February 2nd, 2017
Peru State College, Theatre and Event Center Renovation and Addition
Peru, Nebraska

ADDENDUM #2

1 WELLFIELD PLAN
 MO.1 1/16" = 1'-0"

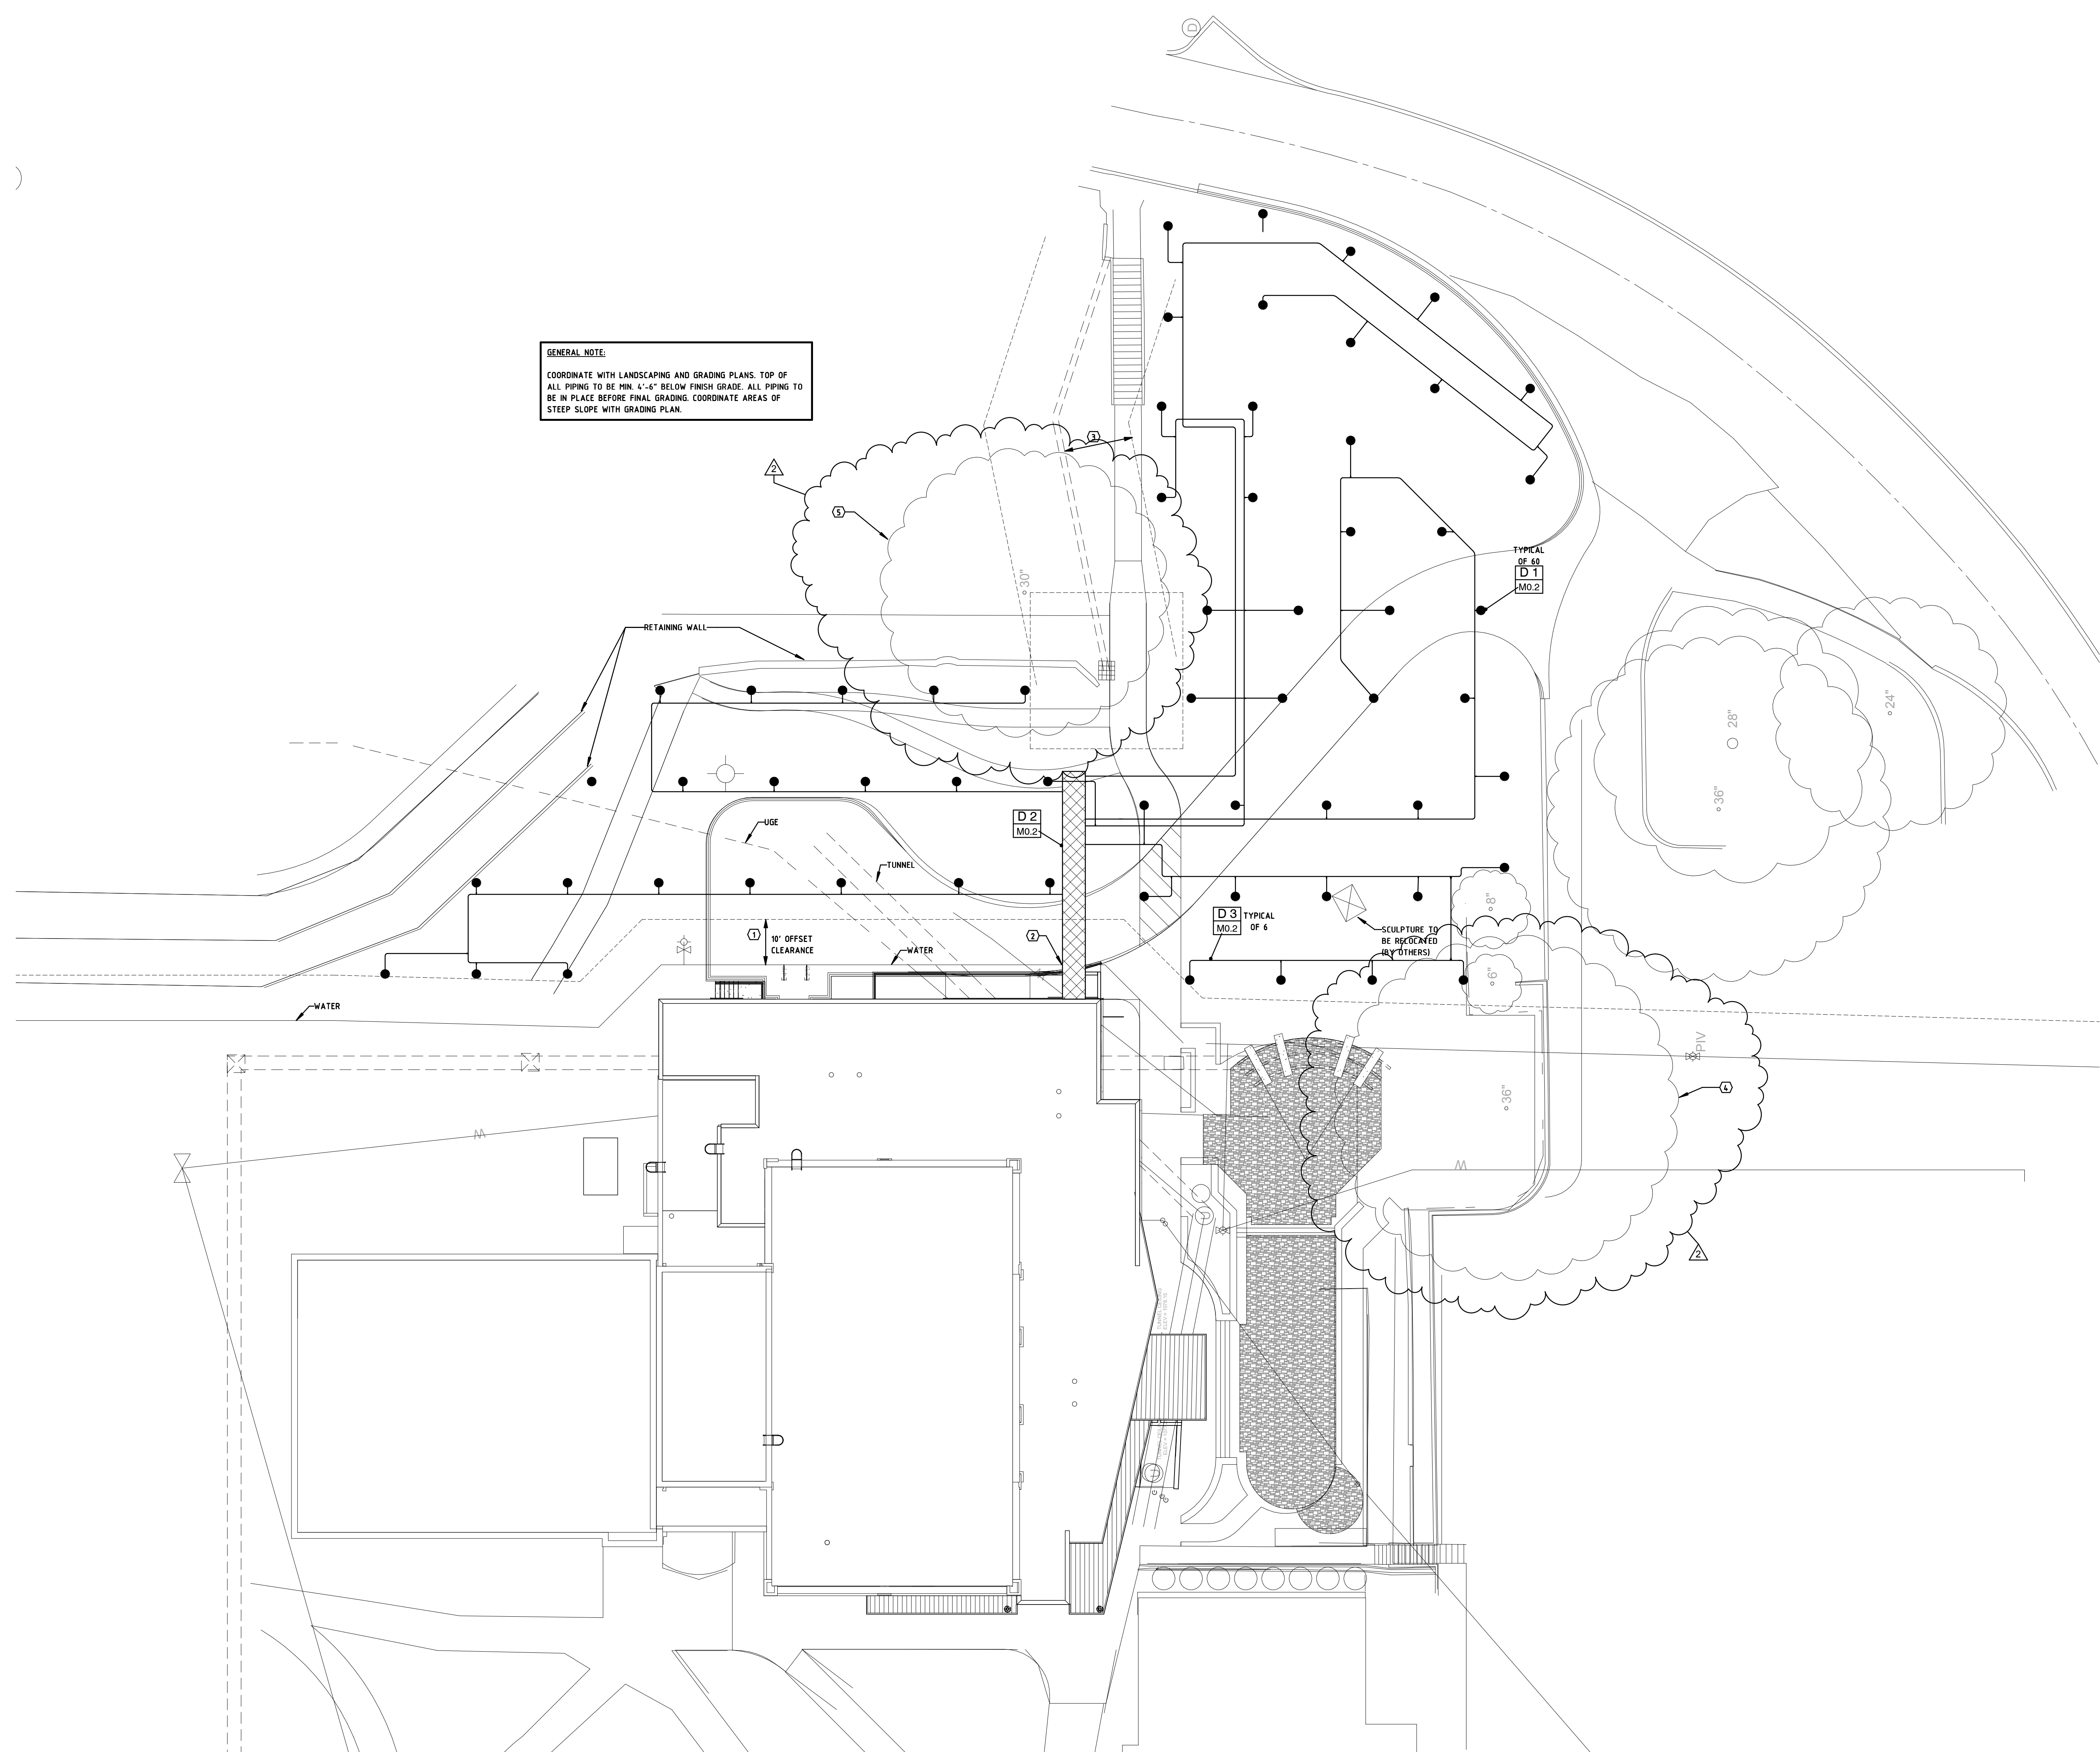
- 1) Two (2) existing trees removed from site, see attached sheet for reference.
- 2) Noted existing tree not to be damaged as part of construction, see clouded area and Keynote #4 on attached sheet.
- 3) Noted minimal branch removal of existing tree is permitted after coordinate with Owner, Architect and Engineer, see clouded area and Keynote #5 on attached sheet.
